# ACCESS REPORT

**Reference Number:** 21188

97-99 Punchbowl Rd, Belfield NSW

This Access Compliance Report is to accompany a Part 5 activity for the development proposed at **97-99 Punchbowl Rd, Belfield NSW**

[Image description: Plan above shows the provision of Accessible parking spaces]

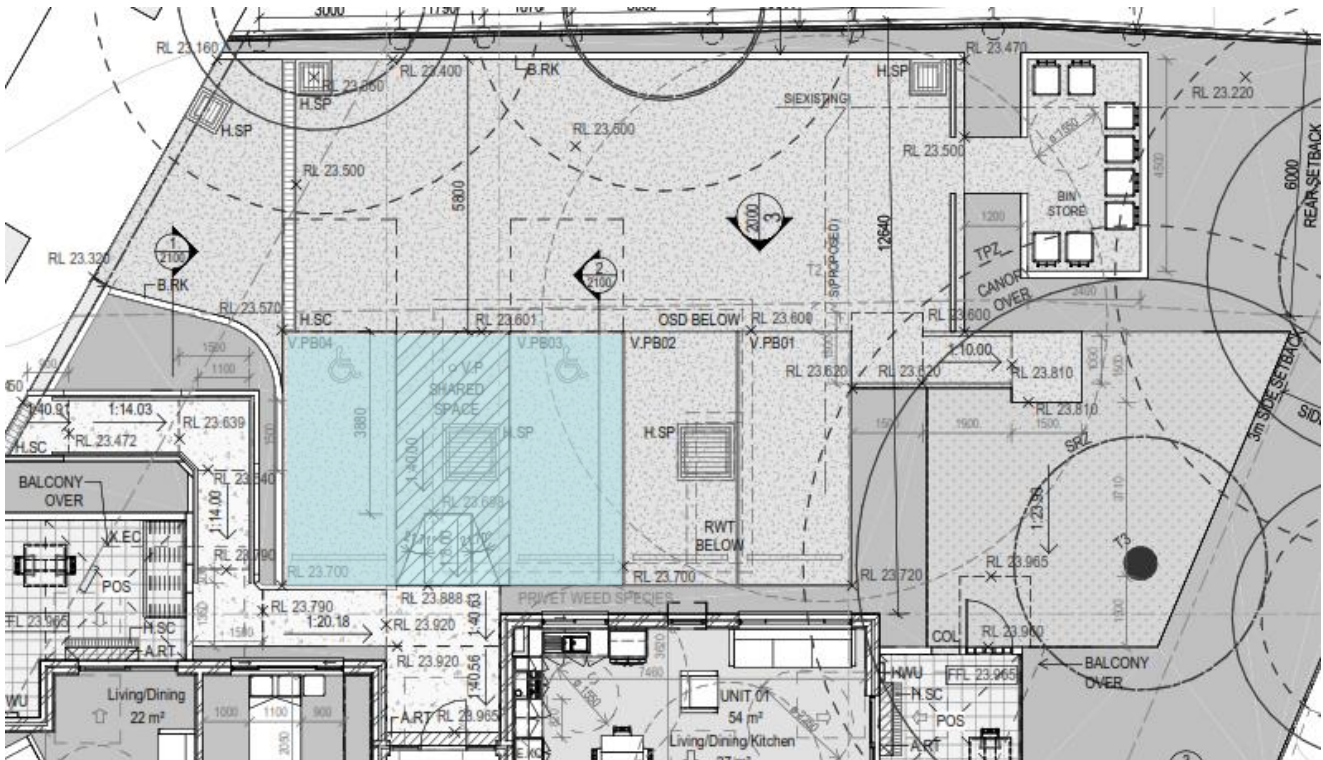
Use of kerb ramp in shared zone will be subject to a performance solution at CC stage of works. Details to be verified at CC stage of works.

### Pathways to Bus stop nominated by town planner

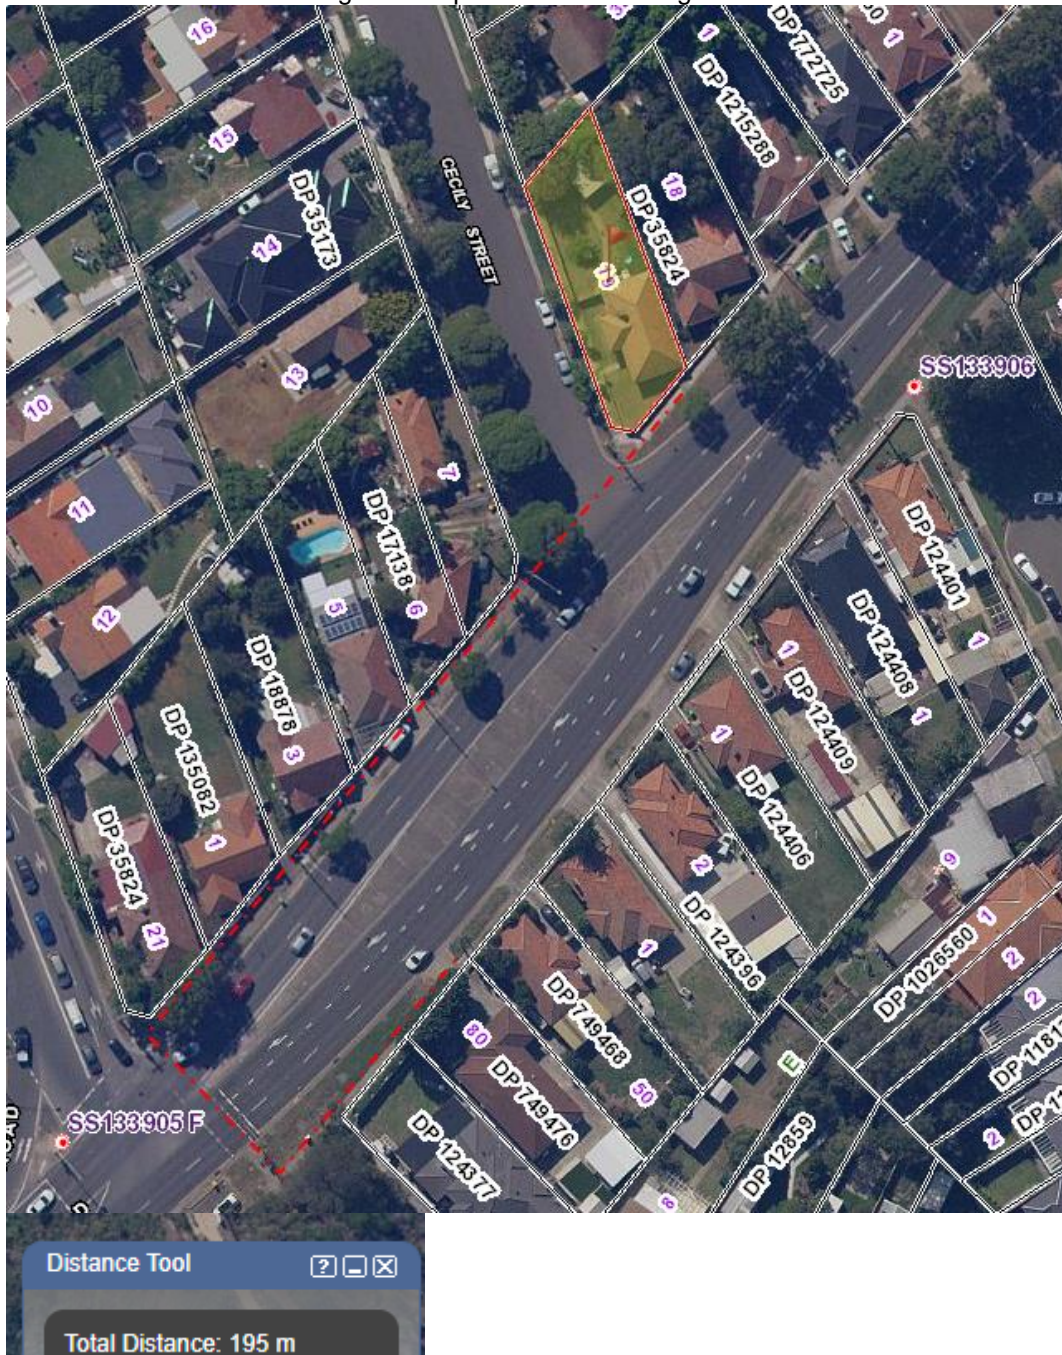
Bus stop to be at a distance of not more than 400 M from the site of the proposed development and the distance is accessible by means of a suitable access pathway.

Compliance      Complies
